Descriptive Report to Accompany Hydrographic Survey H12140

Project OPR-O351-FA-09
Northern Glacier Bay, Alaska
Tarr Inlet to Johns Hopkins Inlet
Scale 1:40,000
September - October 2009
NOAA Ship *Fairweather* (S220)
Chief of Party: Captain David O. Neander, NOAA

Revisions and Corrections Compiled During Office Processing and Certification

Figure 2: Crossline and main scheme differences (white indicates agreement, warm colors indicate a Xls shoaler than mainscheme and cool colors indicate Xls are deeper).

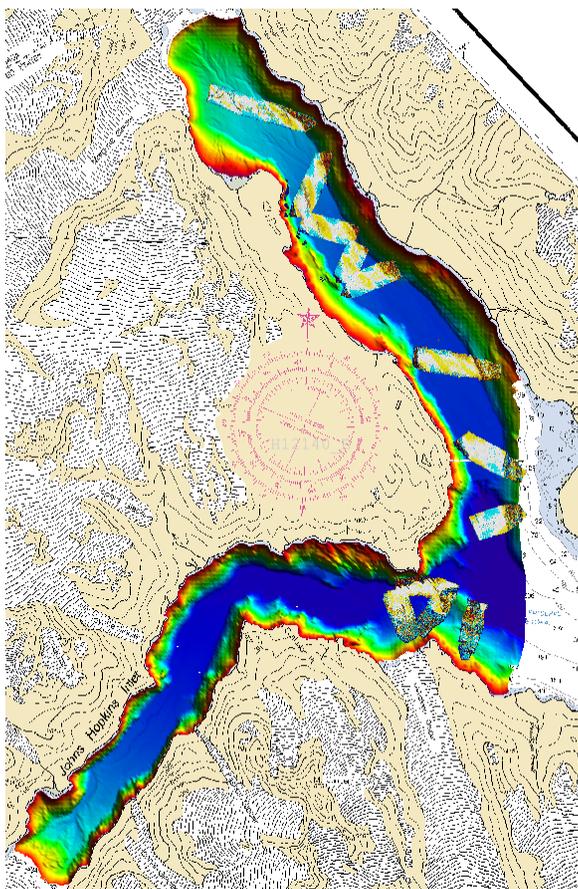
Surface differencing in Fledermaus was used to assess crossline agreement with main scheme, as depicted in Figure 2. The areas in which crosslines intersect mainscheme lines were reviewed in CARIS subset mode by the Hydrographer. The largest deviations were found in areas of steep slope, where slight horizontal positioning differences contributed to extreme apparent vertical offsets.¹ In areas of pronounced slopes differences as large as 10 to 30 meters were observed. In flat areas surfaces agreed well under 1 meter, typically less than 0.3 meters.

¹ Concur with clarification. Higher disagreement is expected in areas of steep slopes. The data has been inspected and deemed adequate for charting.

Figure 2: Junction Between H12140 and H12141

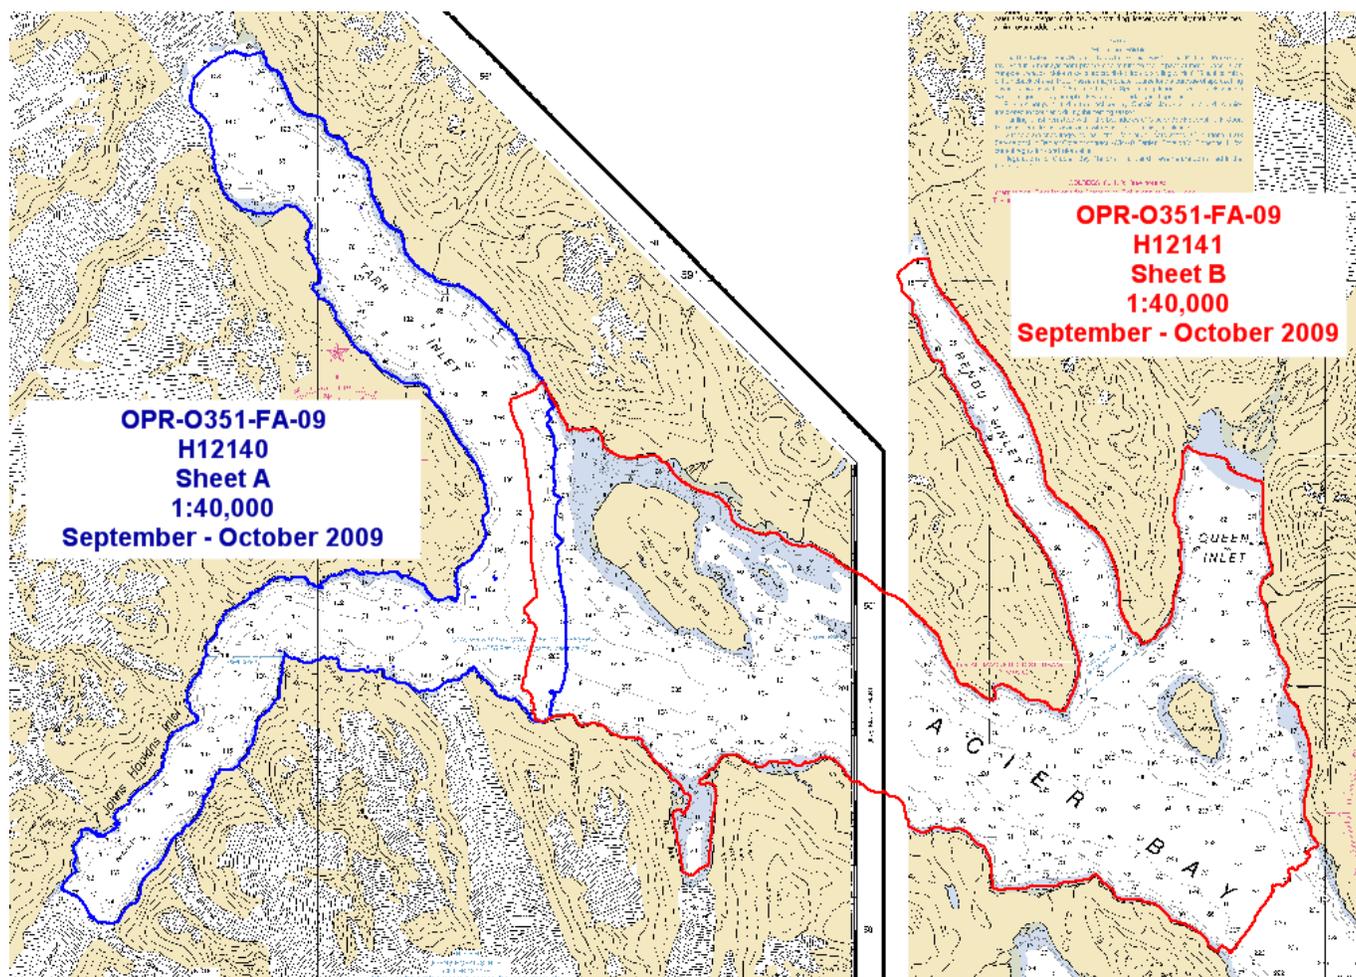
Survey H12140 junctions with H12141, which is Sheet B of the same project.² The area of overlap between the sheets was reviewed in CARIS Subset Editor and Fledermaus for consistency and data were found to be in general agreement. Areas near nadir and with flat relief had excellent agreement within 1 meter in 200 to 300 meters depth. In shoal areas, the extreme relief yielded larger differences due to small horizontal offsets contributing to a reported vertical difference. When observed in CARIS Subset Editor, the offsets were within 0.5 meters in areas less than 4 meters depth.³ The sheet limits and area of overlap for Sheets A and B are depicted in Figure 3.

² A common junction was made with H12141 which has already been compiled.

Figure 4: Launch 1018 DN 273 Sound Velocity Modeling Errors

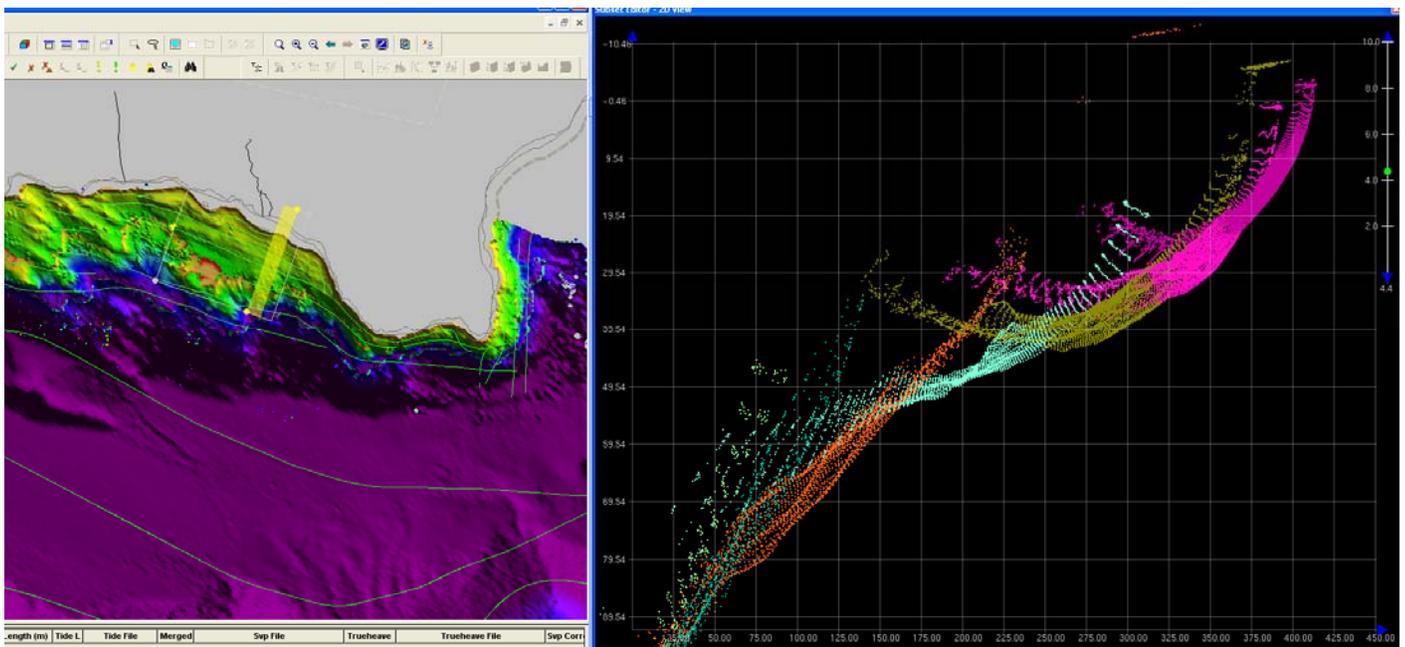
Due to melting glacial ice, river runoff, and the effects of tidal currents, a sharp demarcation of water masses was often visually observed in the field. This proved to be problematic in the acquisition and application of sound velocity correctors. After correction for sound velocity in HDCS, some lines still exhibited the characteristic "smiles" and "frowns" indicative of inaccurate sound velocity corrections, as depicted in Figure 4. Despite the best efforts of *Fairweather* personnel to conduct sufficient sound velocity casts distributed both spatially and temporally to accurately correct the sounding data, sound velocity artifacts are still noticeable in several regions. To compensate, the Hydrographer rejected soundings obviously in error on the outer beams by manually rejecting outer beam soundings when the surface was pulled outside of IHO error tolerance.⁷

⁷ Concur with clarification. The data is acceptable for charting after the outer beams were rejected to mitigate the sound velocity errors.

Figure 5: *Fairweather* (S220) Reson 7111 data shown as top two lines (purple and tan), Reson 8160 System shown as bottom two lines (yellow and cyan).

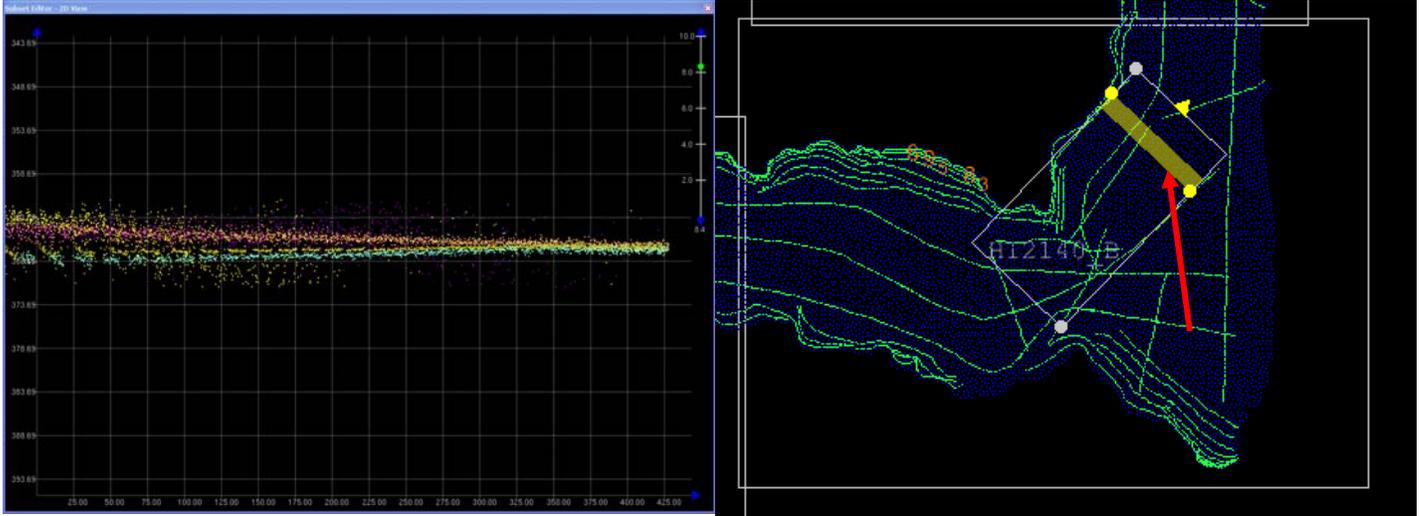
Soundings acquired with *Fairweather's* (S220) RESON 7111 MBES system are observed in many areas to exhibit a vertical offset. The RESON 7111 data are shoaler than surrounding by not more than two meters, as depicted in Figure 5. The degree of this offset does not exceed IHO Order 2 error limits and is typically only evident in water deeper than 250 meters.⁸

⁸ The shoaler data was preserved in the BASE surfaces and is adequate for charting despite the vertical offsets.
